C & D Landfill
2 Landfill Rd
Happy Valley

17 December 2012

RE: Review of Slope Stability for Resource Consent, C & D Landfill, Happy Valley
Our Reference: 09870.000.000

GEOSCIENCE <small>A proud member of</small> ENGEO	Date	14/12/12	Client	C & D Landfill	
	Drawn by	RJ	Project	Review of Landfill Slope Stability for Resource Consent	
	Approved by	GC	Description	Conceptual Stormwater Management Details	
	Scale	NTS	Figure No.	3	Project Number

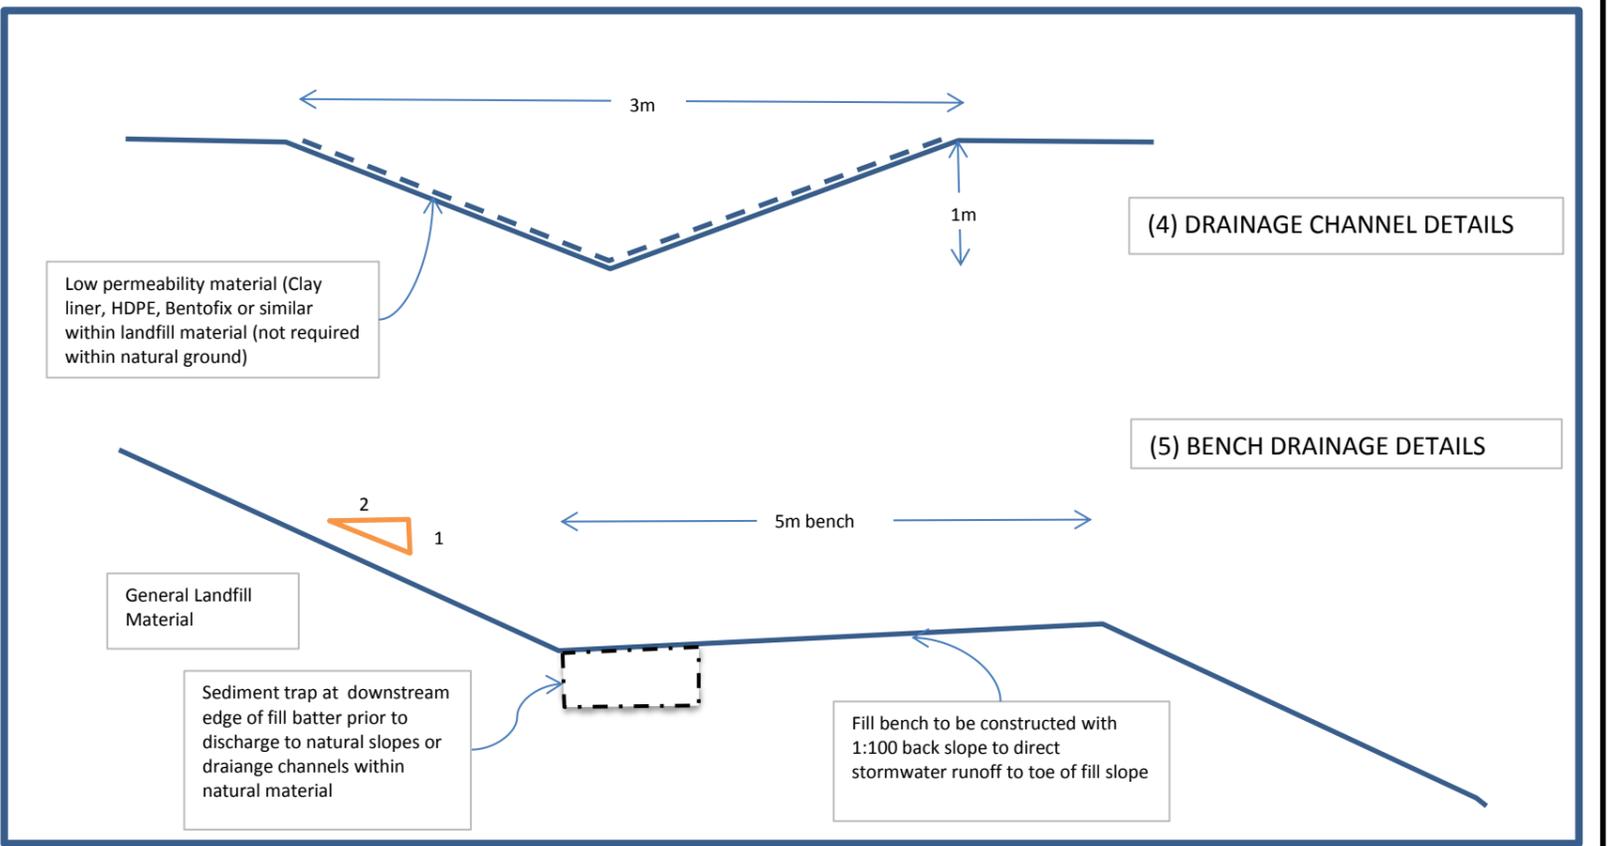
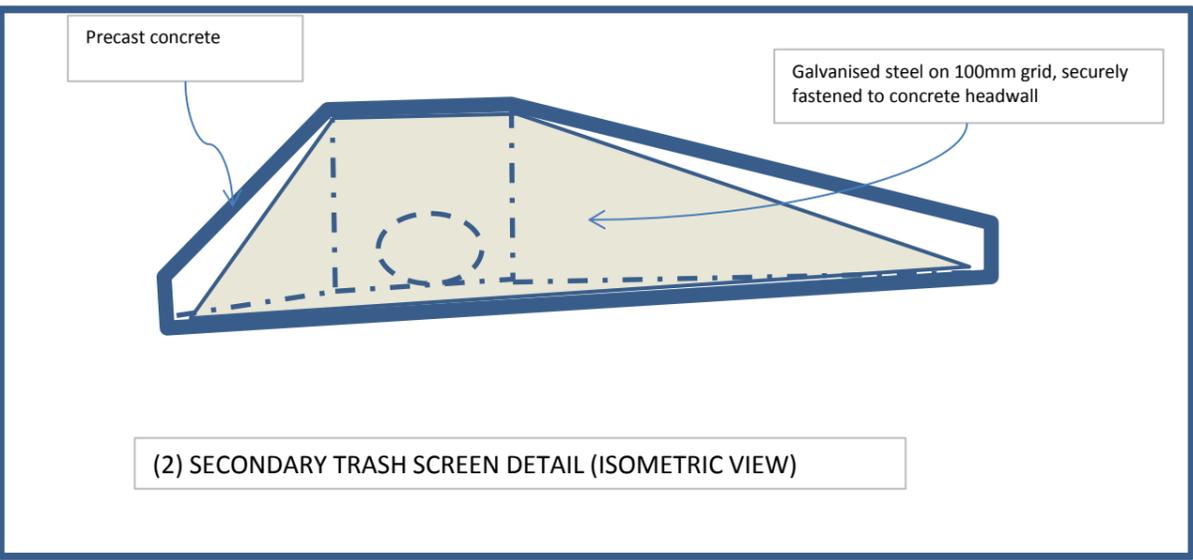
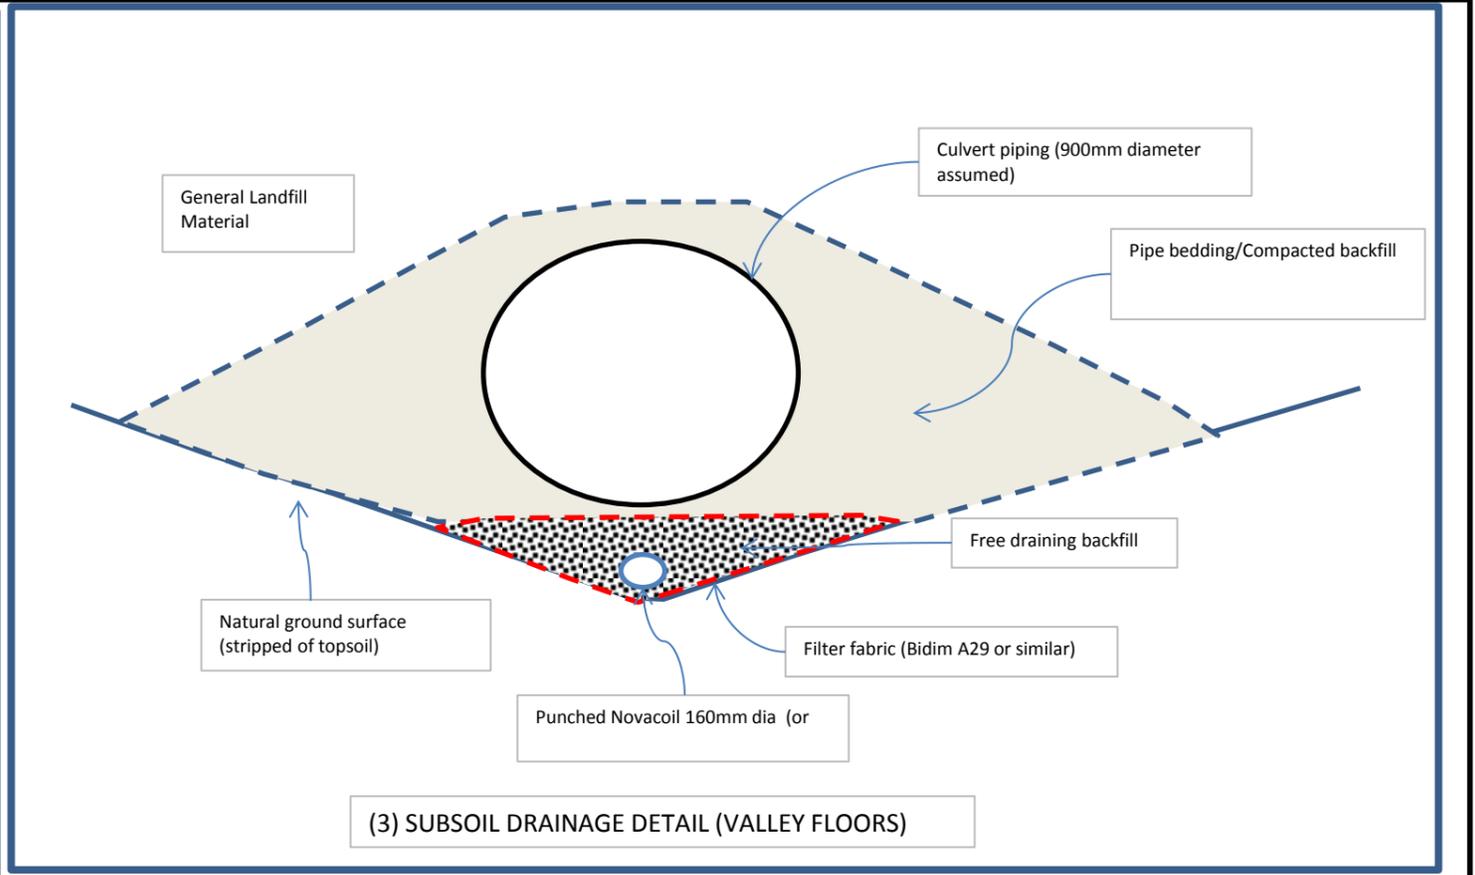
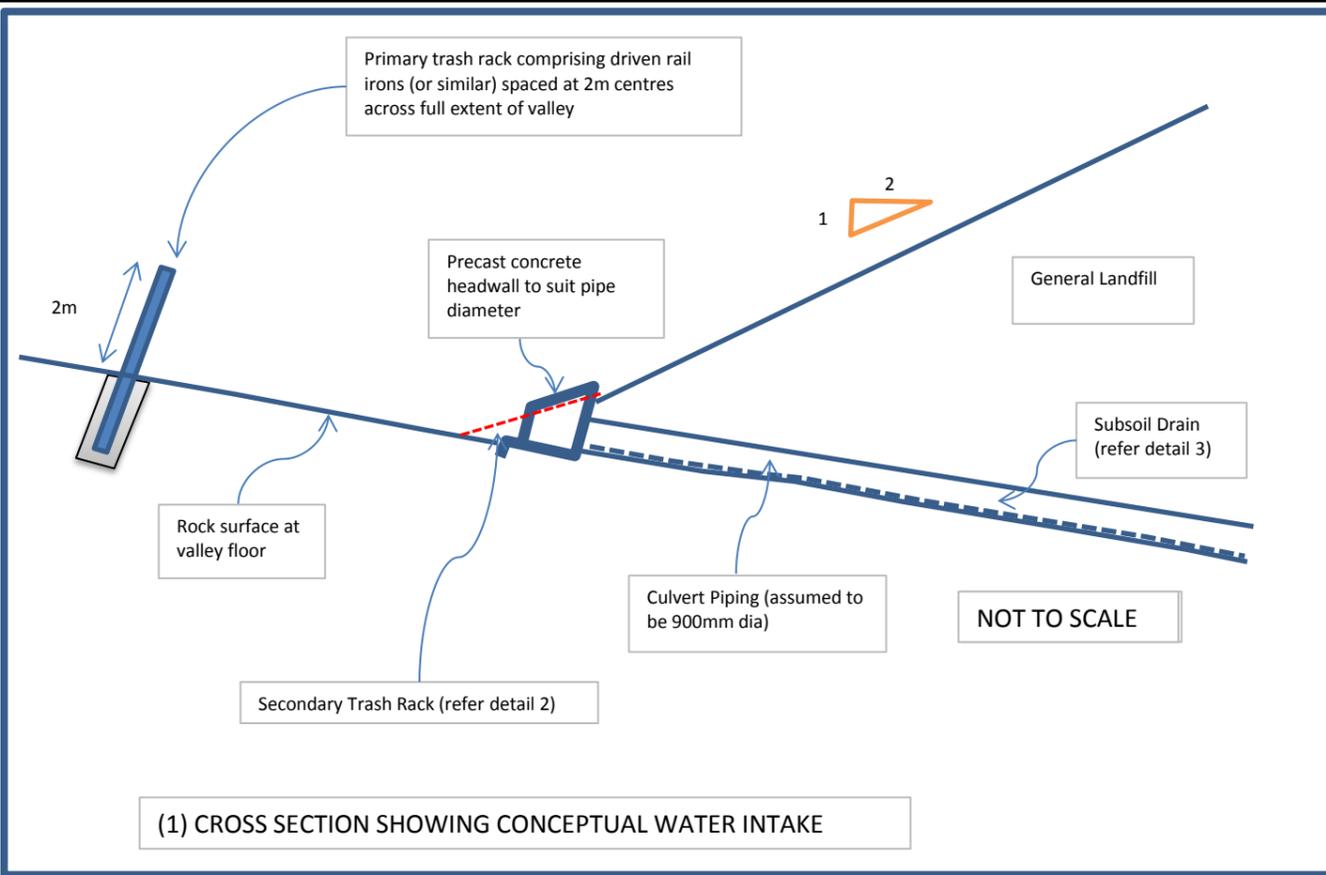
Approximate location of culvert inlet after filling to 150m level (refer Figure 3 for intake details). Intake level to be progressively raised upvalley as filling proceeds
